Road Safety Audit

**SR 306 (Reynolds Road)
and
US 20 (Mentor Avenue)
Intersection
City of Mentor, Ohio**

May 2009

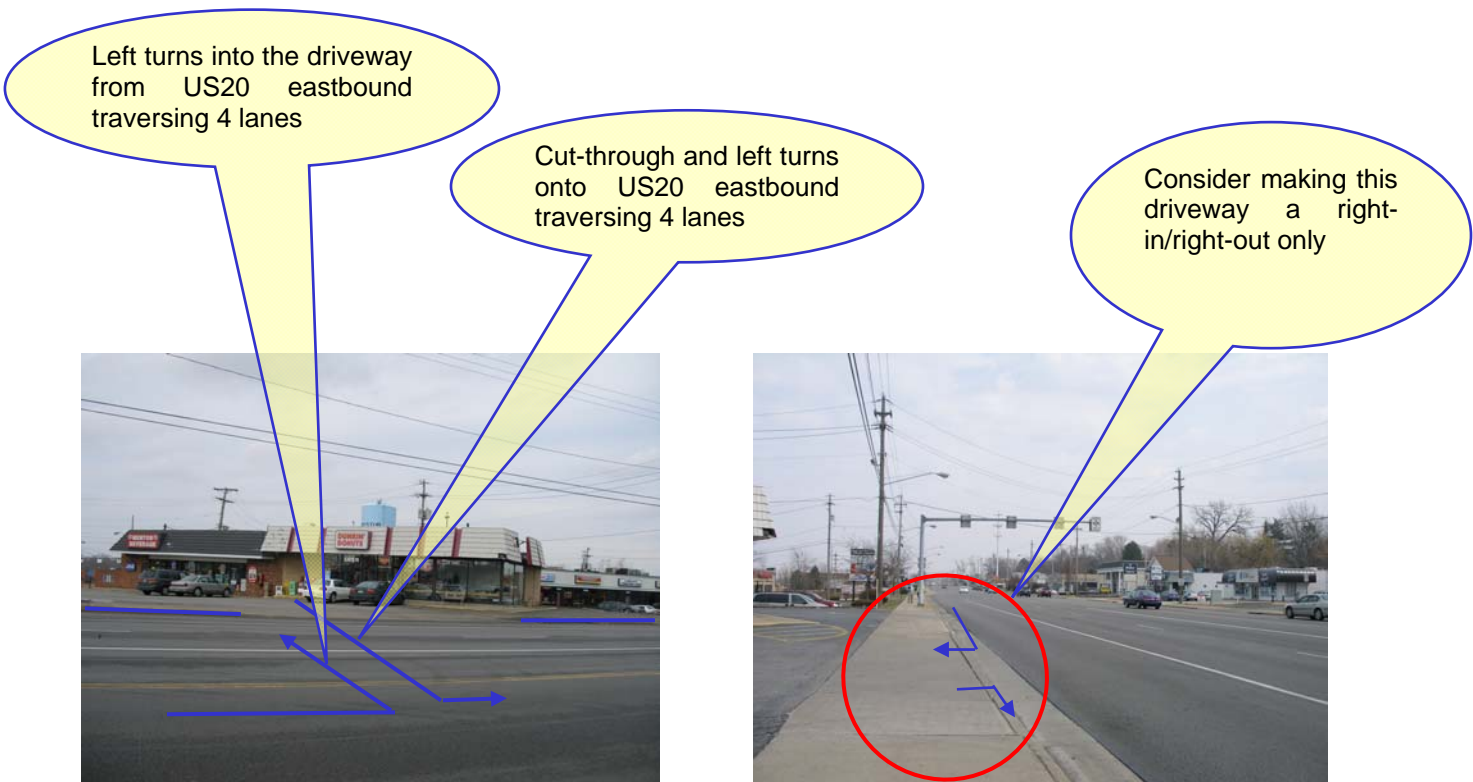
- The pole-mounted traffic signals are intended to control traffic in the channelized right turn lane, but needlessly operate in tandem with the traffic signals mounted on the mast that are intended to control the through and left turn lanes. This causes potential conflicts for traffic movements and confusion to drivers in the channelized right turn lane, especially when conflicting signal indications appear. The following photographs and their captions provide clarifications of real time conditions.

The pole-mounted signals, intended for the channelized right-turn lane, and the mast-mounted signals, intended for the through and left-turn lanes, operate in tandem causing the production of conflicting signal indications, shown in the photos below.

The pole-mounted traffic signal heads are intended to control traffic in the channelized right turn lane on the US20 westbound approach. They, however, operate in tandem with the signals mounted on the mast, which causes some confusion to drivers.

The pole-mounted traffic signal heads on the pole to the left, within the island, is intended to control traffic in the channelized lane as evidenced by its placement and location far to the right of the edge of the roadway for through traffic.

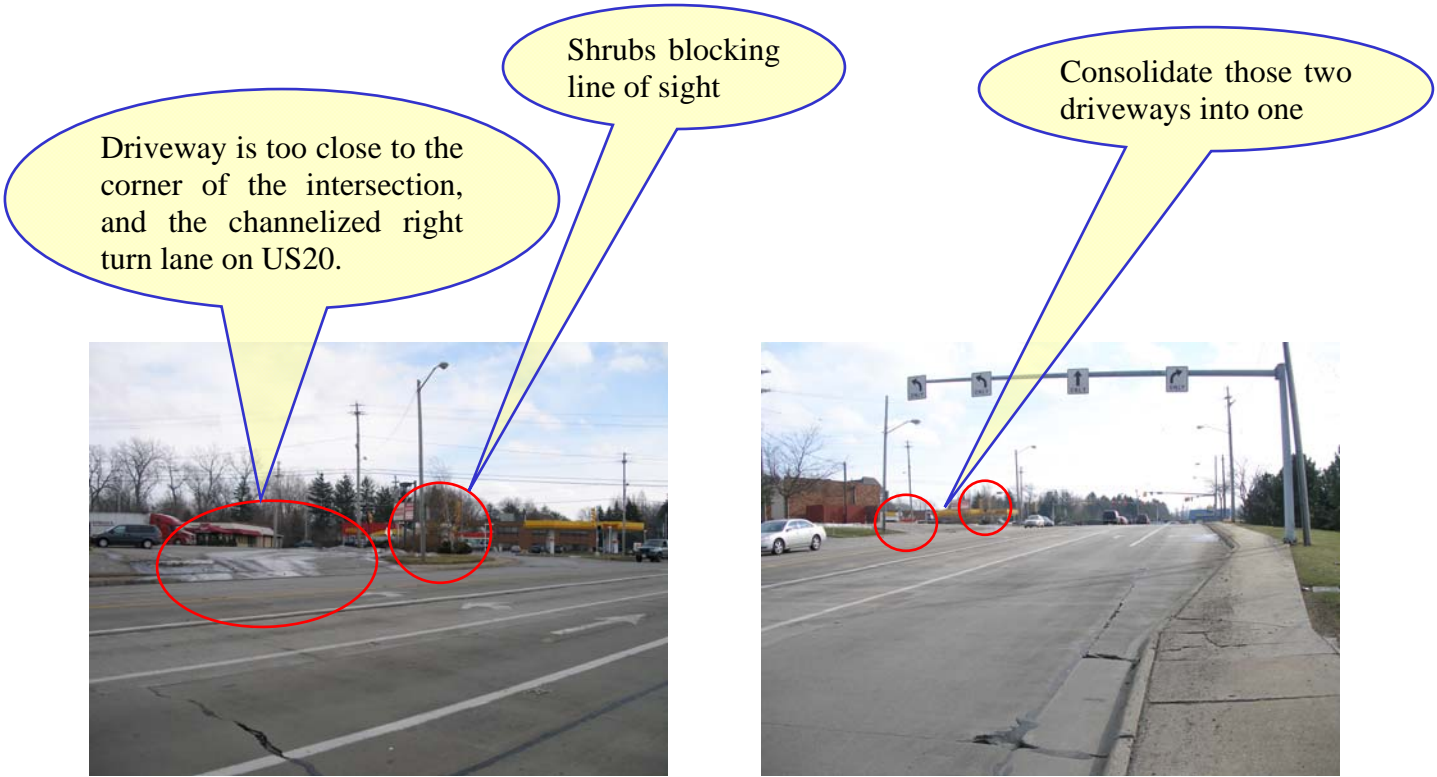
Vehicles in the channelized right turn lane past the pole-mounted signal heads

Signal indications on the pole-mounted signal heads, intended to control traffic in the channelized right turn lane, display conflicting indications

Traffic in the channelized right turn lane turns right onto SR306 northbound from the US20 westbound approach either when the traffic signal indicates right of way or when drivers turn right-on-red.

To some drivers it could be obvious but to others it sends a conflicting message, which causes second thinking and hesitation. Traffic control indications must be clear and intuitive. Obviously, in this case it is not.

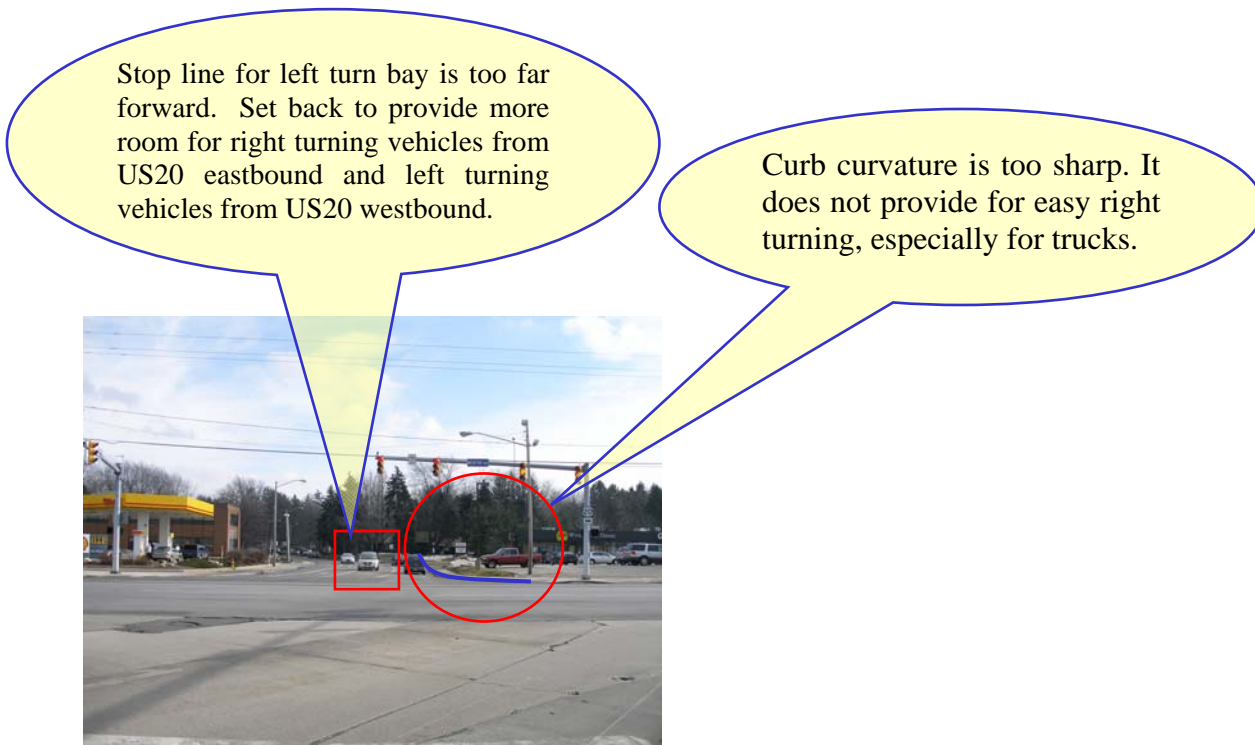
- There are two driveways for the shops in this shopping strip. They can be consolidated and replaced with one driveway to be located farther away from the corner of the intersection.

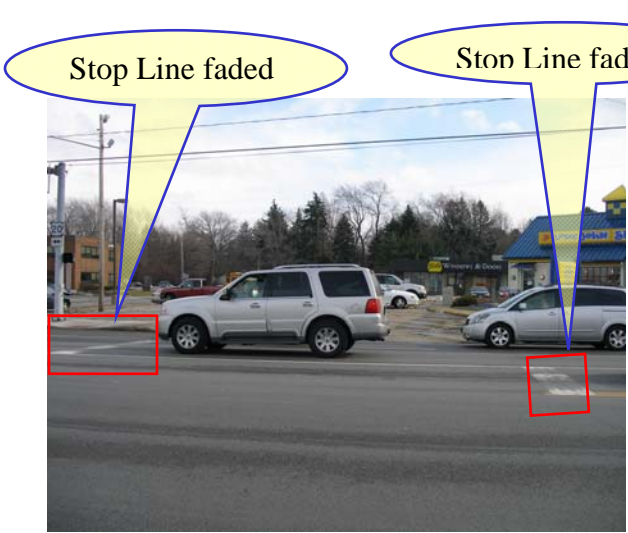
- The stop line for the left turn bay on the northbound approach of SR306 should be offset or staggered from the stop line for the through bay to provide room for southbound left and right turning traffic from US20. The curb curvature on the southwest quadrant should be increased.

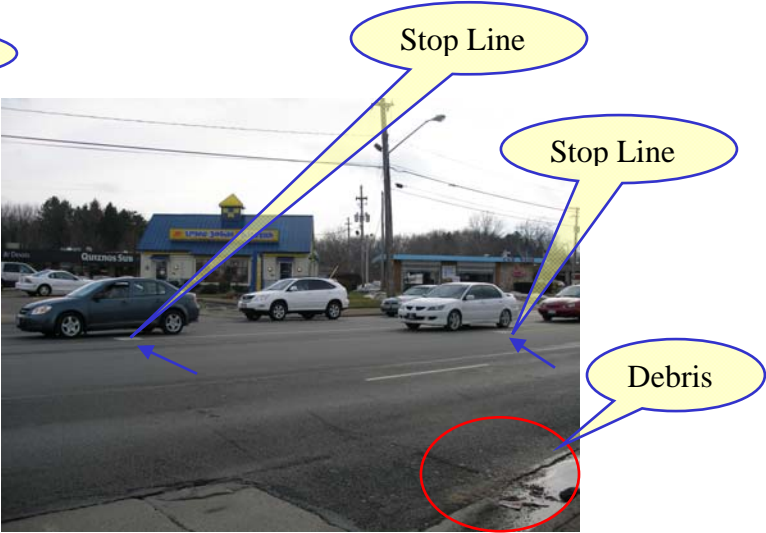
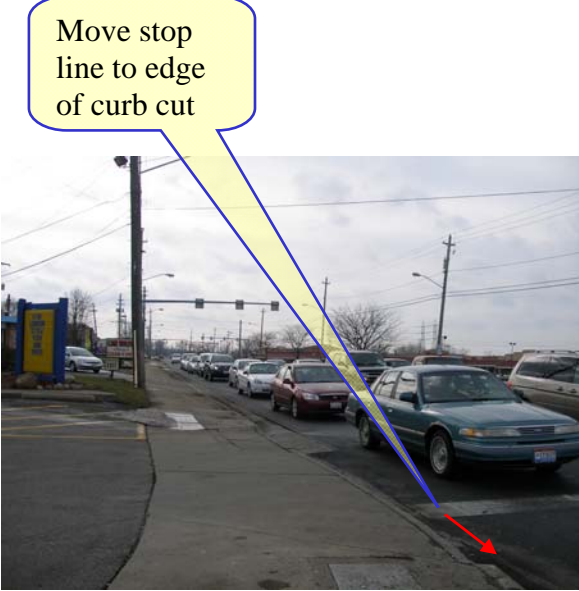
- Stop lines are offset appropriately here. Marking, however, is faded.

US20 eastbound, stop line markings, faded

US20 eastbound, stop line markings, faded

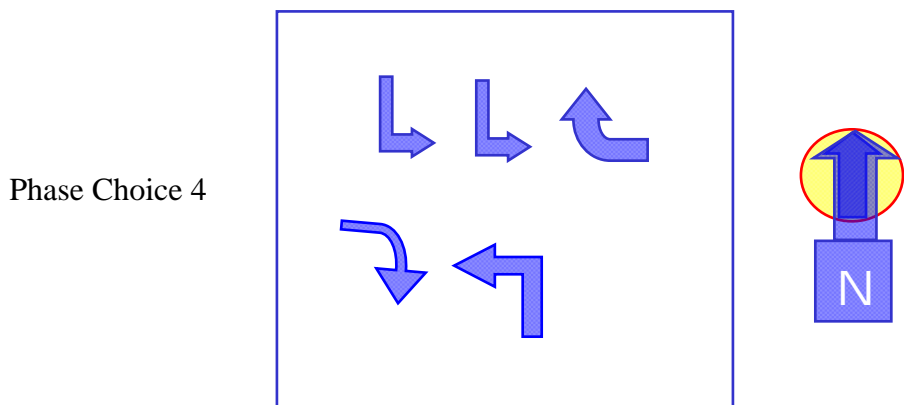
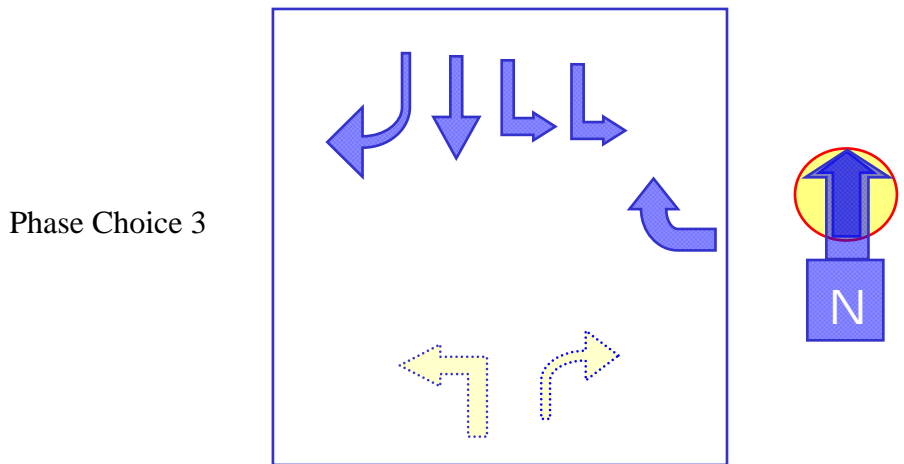
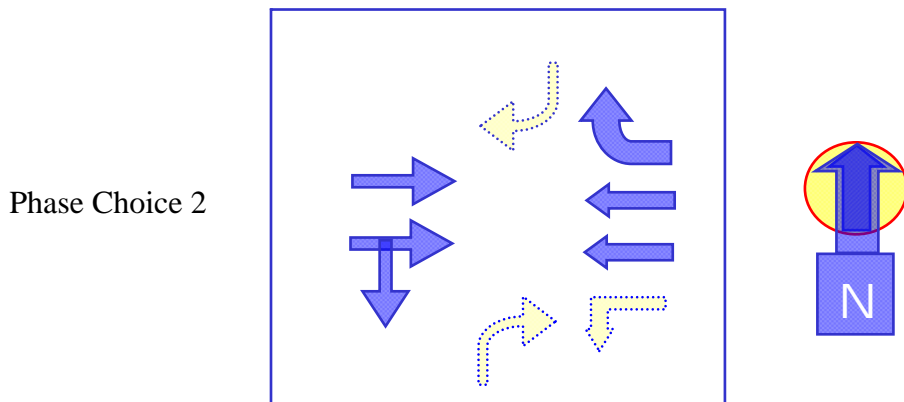
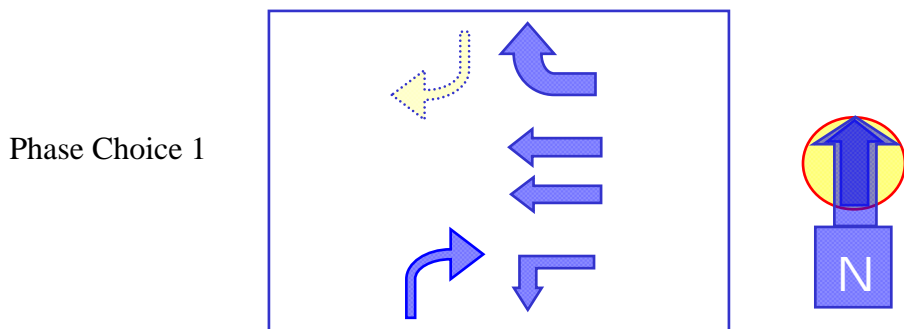
This auxiliary signal head, intended to augment another one for the single southbound through lane of the SR306 leg south of US20 is not needed, as it might mislead drivers to think there are two through lanes.

Lane assignment sign is located too far to the right and far beyond where needed to be seen by drivers.

Phase Choice 5

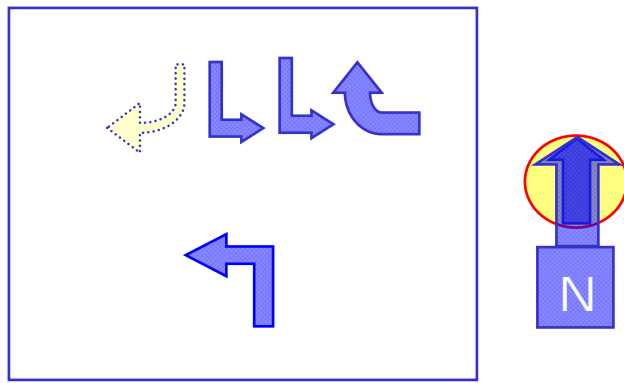
- Right-Turn-On-Red for traffic in the channelized right turn lane must be prohibited. Traffic in this lane can have many opportunities to move within a protected phase. These opportunities can be made available in any one or more of the following possible phase scenarios:

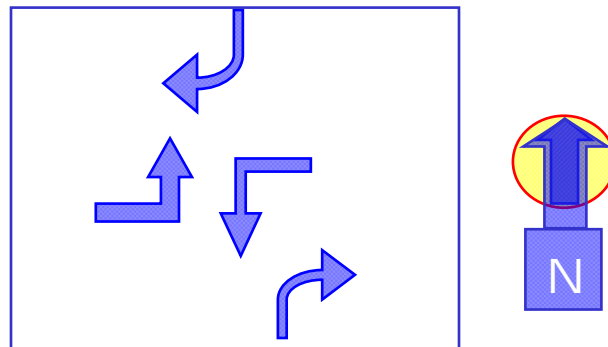
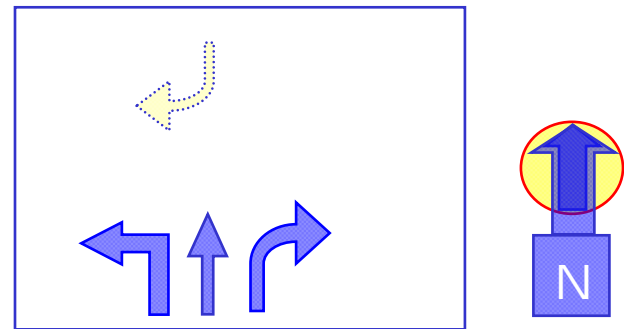
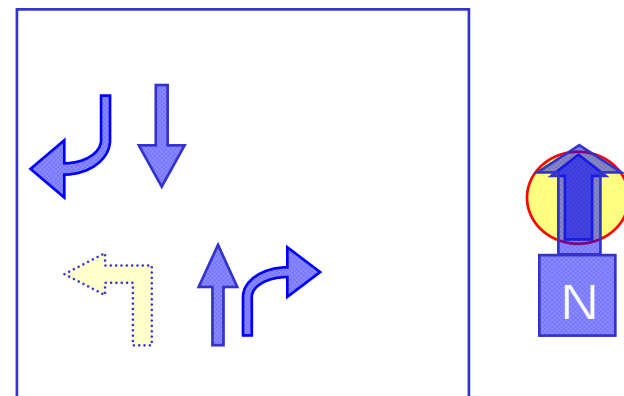
- Primary eastbound and westbound left turn movements from US20 onto northbound and southbound SR306 should be accommodated in protected phases only. Permissive eastbound left turn movements must be eliminated or prohibited and replaced with allowing them only during a protected left turn phase. These left turn movements can be accommodated in any one or more of the following possible phase scenarios:
